Pilbara Iron Ore and Infrastructure Project

Response to Public
Submissions on
Public Environmental
Review
April 2005

**Pilbara Iron Ore and Infrastructure Project:
Stage A Port and North-South Railway**

**Response to Submissions (and additional studies)
EPA Assessment No. 1505**

Fortescue Metals Group Limited	
Figure 2. 'Indicative Port Layout'	
Author: FMG	Date: 6th April 2004
Drawn: P Sawers	Revised: 10/03/2005
Dwg No.: FMG 05019	Report No.:
Projection: GDA 94 Zone 50	Scale: 1:25,000

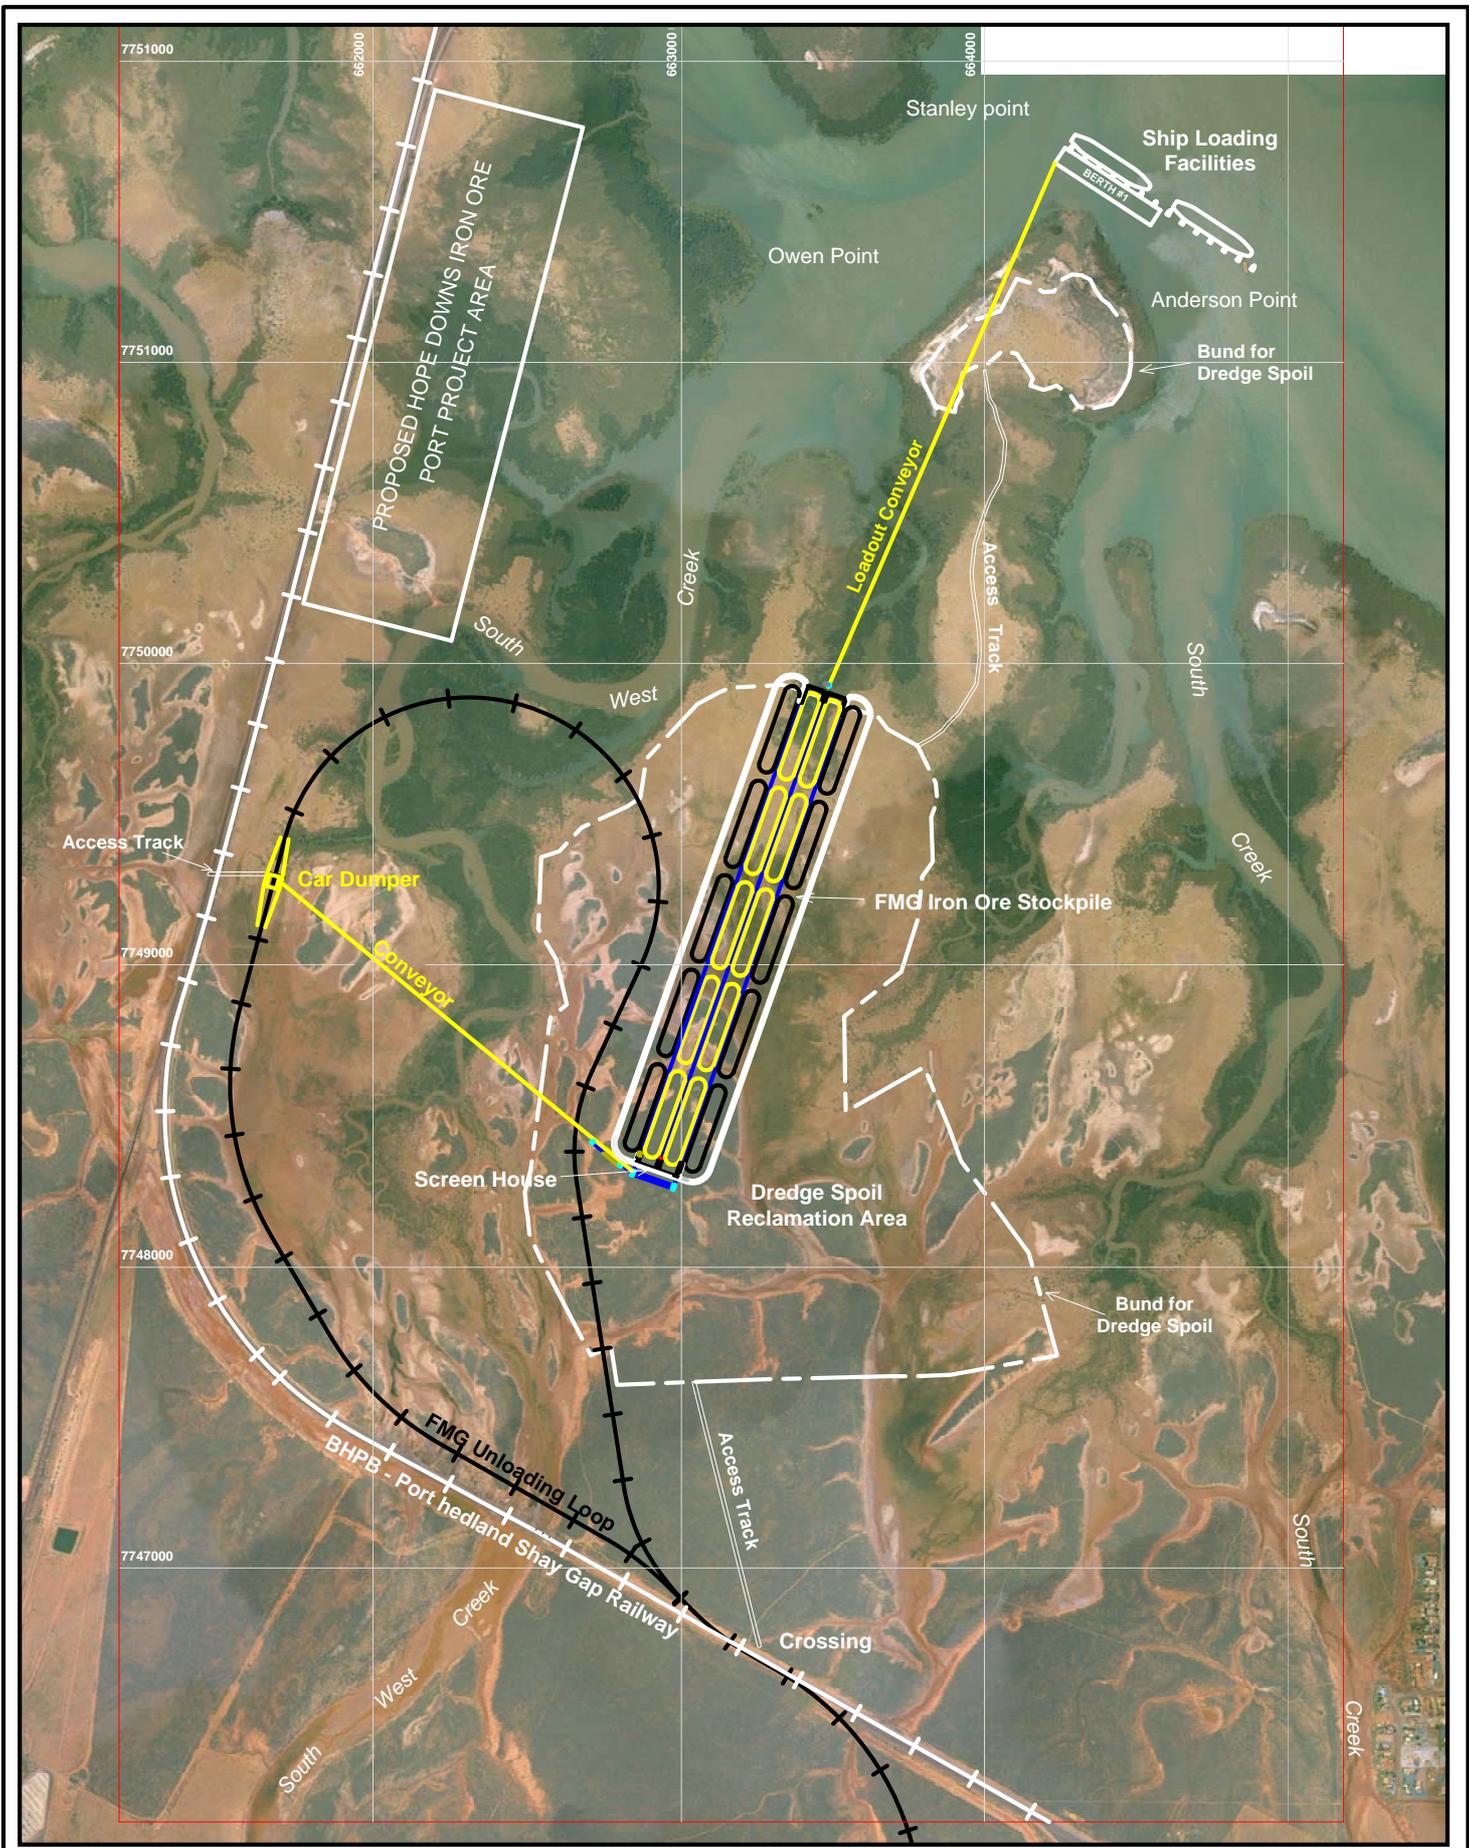
5.3.8 Concerns over the amount of bund wall which will be directly abutting the surrounding mangrove habitat and the effect the change in flooding regime would have over these affected mangrove areas. Would like to see efforts to decrease the amount of bund wall that directly abuts the surrounding mangrove habitat. Would like to see measures put in place at bund wall/mangrove interface to maintain the tidal flushing and prevent inundation (Submissions 10, 11).

These revisions have reduced mangrove clearing by an additional 7.2 ha and reduced the overall proportional loss of core mangrove within the harbour from 22 ha to 14.8 ha (Figure 2 shows the amended Port layout). This was achieved by adjusting the boundaries of the dredge spoil reclamation area to avoid mangroves and impact bare mudflat or terrestrial areas instead. Cyanobacterial algal mats have not been included in the calculations as mangroves as they do not fall within the assessment framework of EPA Guidance 29 which defines Benthic Primary Producers as:

A: FMG has revised its port design since that published in the PER. One aspect that was changed substantially was the configuration of the bund walls on both the main spoil basin and the Anderson Point spoil bars. FMG has restricted the bund wall to the landward side of the core mangal areas, and therefore the bund wall will not interfere with tidal flushing regimes. However, FMG intends to monitor the mangroves on the seaward side of the bund wall and implement remedial measures should the altered hydrodynamics (e.g. due to seepage from the bunded spoil reclamation area) result in adverse impacts on adjacent mangroves. See Section 7.3.2.2 of the Stage A PER (page 145).

PILBARA IRON ORE & INFRASTRUCTURE PROJECT		
RAIL FACILITIES		
MARSHALLING YARDS & LOOP		
PER CORRIDOR LAYOUT		
PROJECT No:	DWG No:	REV:
300/07519	06100-RA-SK-0013	A

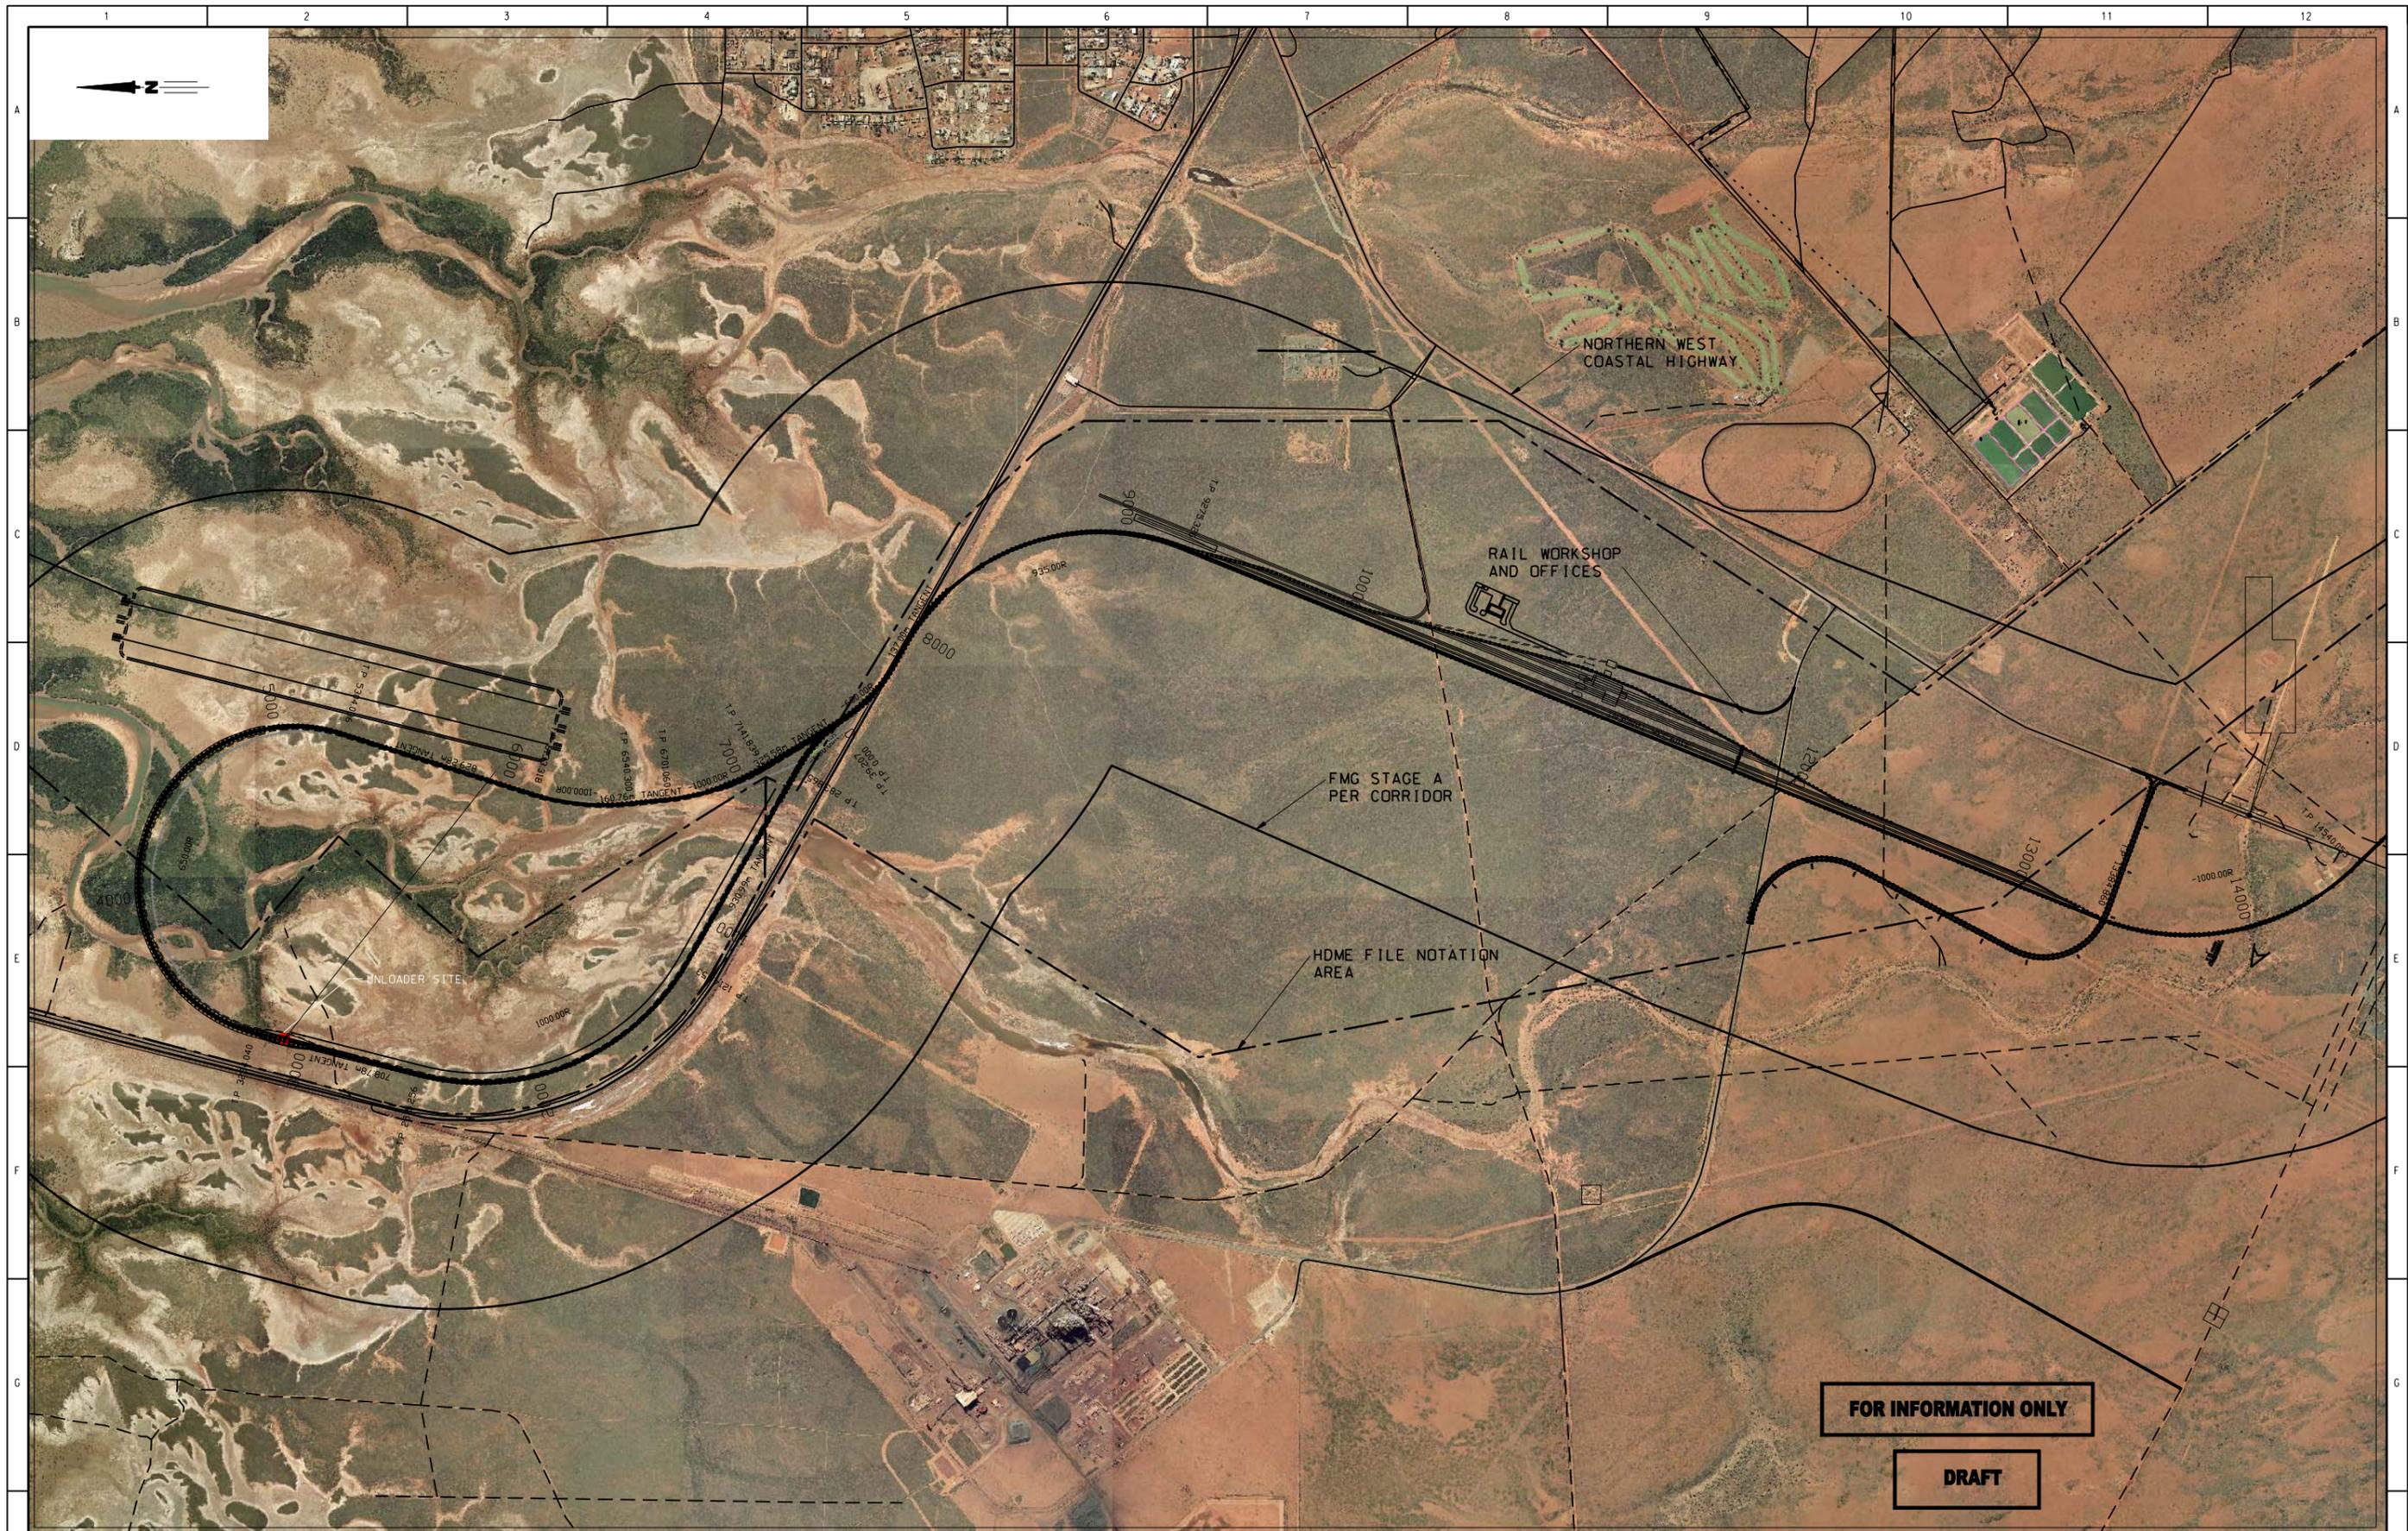
8.10.5 Figure 5 of the PER also does not show FNA 5145, although it is shown (at a much larger scale) in Figure 3a. This may result in some confusion by the reader (Submission 4).

8.10.7 The area of FNA 5145 falling within the PHPA lease, which is designated for the HDMS Project by the Iron Ore (HDMS) Agreement (1992) as amended on 22 October 2003, is currently the subject of discussions to finalise a lease to be issued to HDMS by the Port Hedland Port Authority (PHPA). In the FMG PER, Figure 5 shows a large rail loop overlapping this area and use of this land is referred to in the letter from Alan Watling to Russell Tipper, dated 30th August 2004 and contained in Appendix D. Use of this land by FMG has been discussed with HDMS and HDMS has advised that it is not acceptable (Submission 4).

A: The original figure over which FMG's and HDMS' proposed infrastructure has been overlain was from the Port Planning Study Phase 2 Report (August 2003) for Port Hedland which did not show FNA 5145. Refer to Figure 3 (attached) which shows the HDMS FNA in relation to FMG's proposed rail layout at Port Hedland. FMG has recently completed an "Evaluation of Port Layout Alternatives" (Appendix 1) and the HDMS FNA 5145 is displayed on Figure 7 in this document along with an explanation of the relationship between FMG layouts and PHPA planning areas.

A: The arrangement of the facilities of the marshalling yards is such that FMG's rail marshalling yards are to the east of FMG's main line, whereas HDMS is located to the west. As the tracks are separated in the area between BHPBIO railway and the North West Coastal Highway it should not unduly impede HDMS operations. Figure 3 shows the proposed location of FMG marshalling yards. FMG remains willing to exchange detailed information of rail and related infrastructure layouts with HDMS to come to a mutually beneficial outcome.
